From: Jeanette Coffin
Sent: Tuesday, February 01, 2022 3:24 PM
To: wpein@nc.rr.com
Cc: Colleen Willger; Sarah Vinas; Adam Searing; Amy Ryan; Camille Berry; Jeanne Brown; Jess Anderson; Karen Stegman; Michael Parker; Pam Hemminger; Paris Miller-Foushee; Tai Huynh; Amy Harvey; Ann Anderson; Carolyn Worsley; Laura Selmer; Loryn Clark; Mary Jane Nirdlinger; Maurice Jones; Rae Buckley; Ran Northam; Ross Tompkins; Sabrina Oliver
Subject: FW: West Franklin Street Petition
Attachments: W Franklin Concept.pdf

From: Wayne Pein <wpein@nc.rr.com>
Sent: Tuesday, February 1, 2022 12:35 PM
To: Town Council <mayorandcouncil@townofchapelhill.org>
Subject: West Franklin Street Petition

West Franklin Street Proposed Bicycle Facilities

From: Geoffrey F. Green <geoff@stuebegreen.com>
Sent: Wednesday, February 2, 2022 4:41 PM
To: Town Council <mayorandcouncil@townofchapelhill.org>
Subject: Franklin Street bike lanes

Option E: Existing Configuration (pre-pandemic).

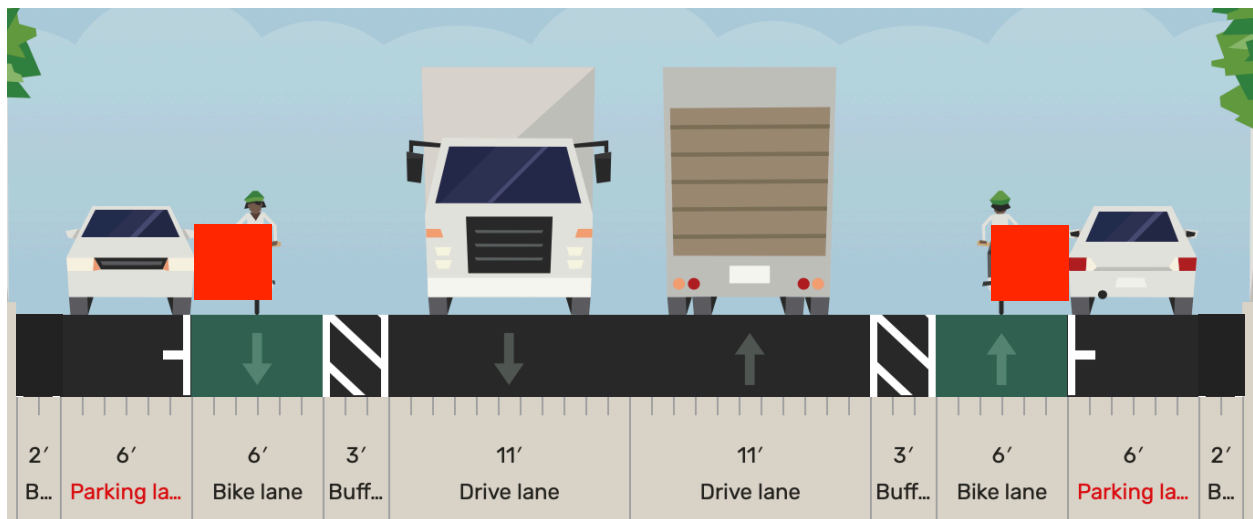
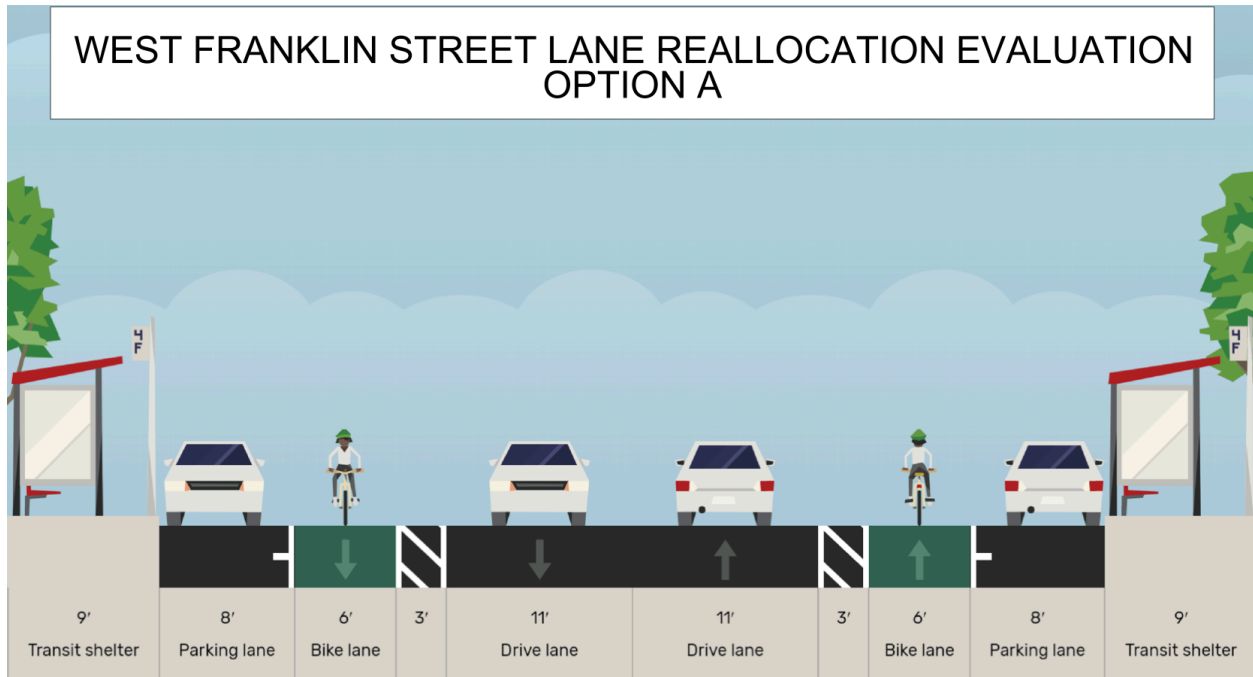
Curb face-to-face is 56'. Shared Lane Markings (**Sharrows**), which are similar to bike lane markings, are shown to portray and highlight optimal user behavior. They could have been placed lane center a decade ago to reinforce bicyclist legitimacy and to provide ongoing education to all road users. BICYCLISTS MAY USE FULL LANE signs (R4-11) with CHANGE LANES TO PASS placards could also be placed.

1. Bicycle drivers should control the right lane as do motorcyclists and other drivers, setting the speed of following traffic. If a bicyclist does 10 mph trailing motorists must do 10 mph. Lane control results in maximum visibility and creates a maximally wide personal Space Cushion — a safety buffer — on bicyclists' left and right. Lane control is a defensive bicycling (and motorcycling) strategy that does not require any special skills, strength, or high bicycle speed. In essence, bicyclists use the lane as if it is a 10.5" wide bike lane. See also:

The original pre-pandemic Existing Configuration of West Franklin Street provided normal and optimal traffic operations and the most safety, mobility and access for bicyclists and all vehicle drivers.

Option A: Door Zone Bike Lane.

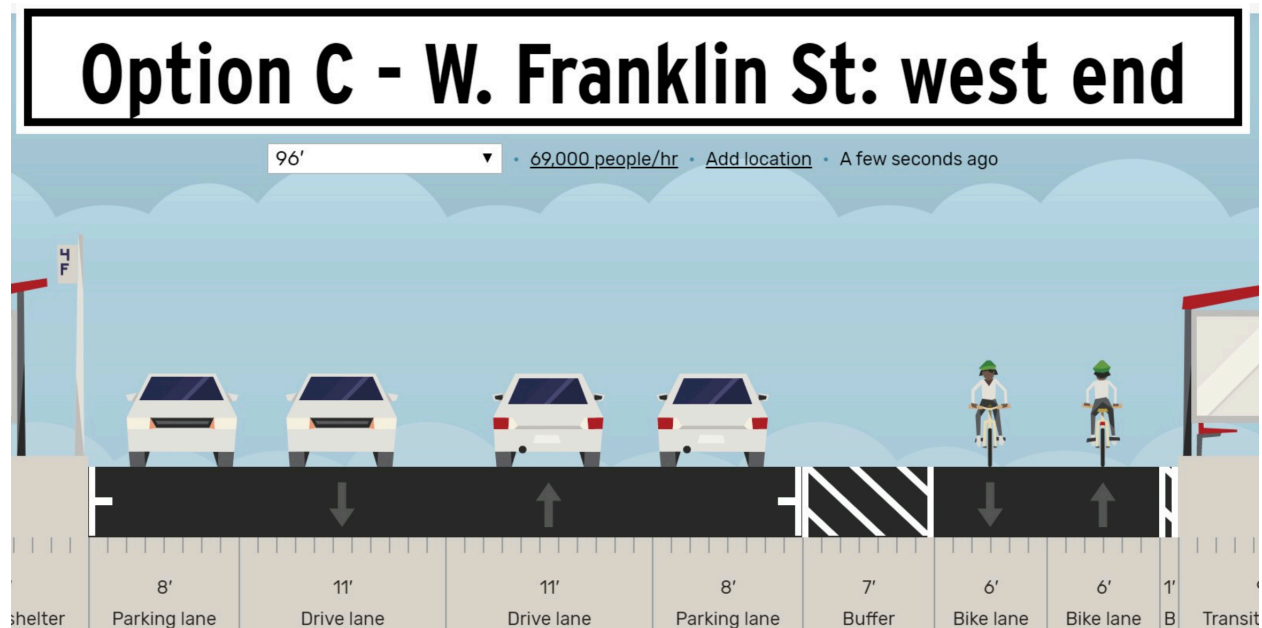
The top image was produced by Town staff. I drew the lower image which more realistically shows parked vehicles abutting the parking line with red doors extending as much as 3.5', and trucks (or busses) rather than cars.

This reallocation changes the right lane from a multi-user lane into a bicyclist exclusive lane. It is a quasi 4-lane road, but motorists are restricted into a single lane in each direction. This greatly alters traffic operations for the worse, and manufactures a number of crossing conflicts that did not previously exist and increases the risk of inherent conflicts.

1. Right Hooks. Motorists normally make right turns from the right lane. With bike lanes present, motorists must turn across the bike lane, creating the risk of Right Hook collisions. Drivers stopped or slowed in a queue may do this suddenly and encounter faster bicyclists passing on the right.

2. Parallel Parking. Motorists wishing to park normally drive in the right lane. With bike lanes, motorists will quickly merge or turn into or across the bike lane to parallel park, conflicting with any bicyclists present. Motorists entering and exiting parallel parking will block the bike lane.

10. Dooring. The bike lanes are partially in the Door Zone. Parked vehicles' sides can abut the parking lane line, and opened doors will extend into the bike lane. If instead of a 6' bike lane and 3' of buffer the allocations are instead 2' buffer - 5' bike lane - 2' buffer as shown in the RKA Pavement Marking Plan, there would be less intrusion into the Bike Lane from car doors, but there would still be a Dooring collision risk.

Option B: Bike Path Behind Parking (abandoned)

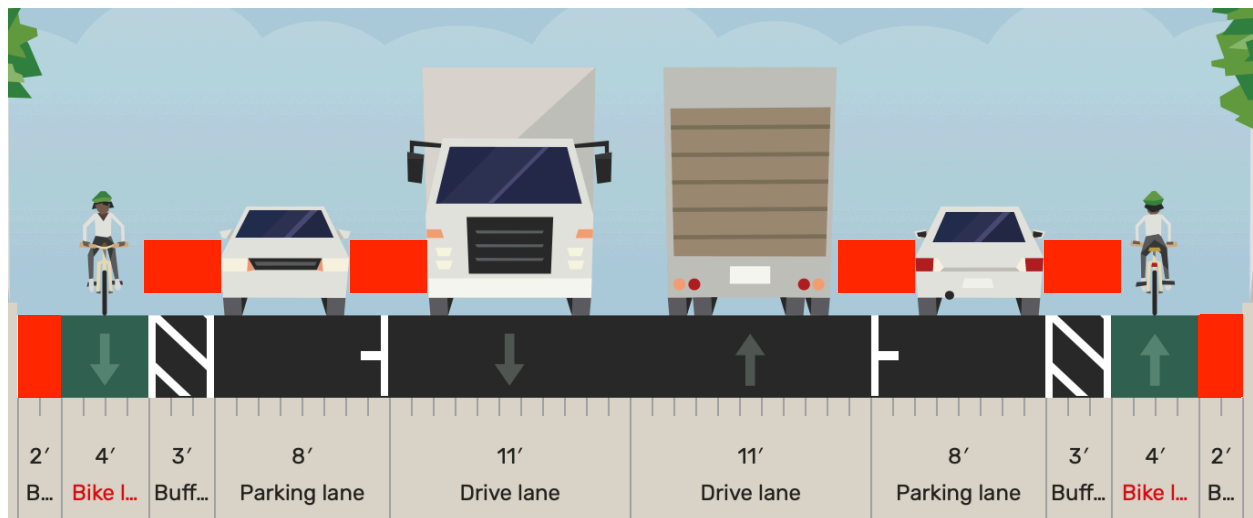
The above image was produced by the Town. The following image is a more realistic rendition showing doors, which on some vehicles can open as much as 3.5", and 2' of buffer bicyclists require from vertical curb faces.

This type of bicycle facility is often called a “protected bike lane.” But since it is behind parking, it’s not a lane but rather a semi-segregated path, and “protected” is a misnomer. This configuration substantially changes traffic operations, manufactures conflicts that did not previously exist and greatly increases the existing risk of conflict and collision.

2.Right Hook. Motorists making right turns will cross the bike lane and encounter unseen bicyclists hidden behind the parked cars. Bicyclists don't see the turning motorists either. This is a serious conflict and Right Hook collision risk that did not previously exist.
